RENESAS TECHNICAL UPDATE

Product Category	MPU/MCU		Document No.	TN-78K-A011A/E	Rev.	1.00
Title	Correction for Incorrect Description Notice 78K0R/Lx3-M Descriptions in the User's Manual: Hardware Rev. 1.00 Changed		Information Category	Technical Notification		
Applicable Product	78K0R/Lx3-M Group	Lot No. All lots	Reference Document	78K0R/Lx3-M User's Manual: Hardware Rev. 1.00 (R01UH0182EJ0100)

This document describes misstatements found in the 78K0R/Lx3-M User's Manual: Hardware Rev. 1.00 (R01UH0182EJ0100)

1. 15.2 Configuration of LCD Controller/Driver
   Figure 15-1. Block Diagram of LCD Controller/Driver (Page 619)

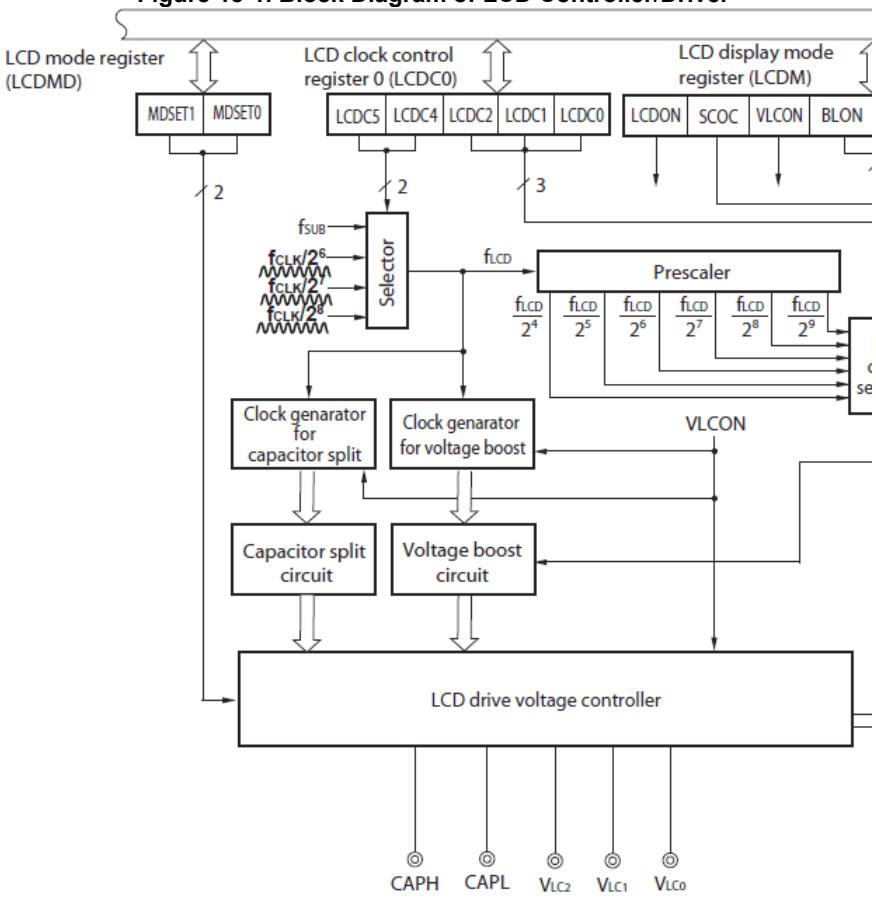
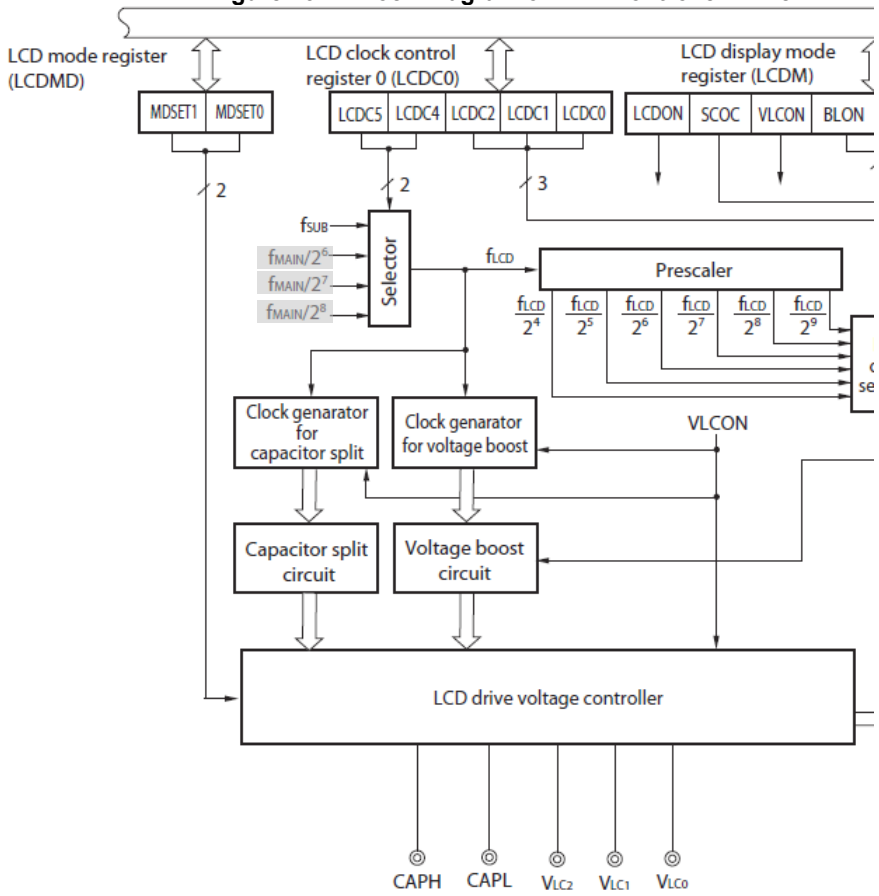
Applicable Item	Applicable Page	Contents
15.2 Configuration of LCD Controller/Driver Figure 15-1. Block Diagram of LCD Controller/Driver	Page 619	Incorrect descriptions revised
15.3 Registers Controlling LCD Controller/Driver Figure 15-4. Format of LCD Clock Control Register (LCDC0)	Page 622	Incorrect descriptions revised

Incorrect:

Correct:
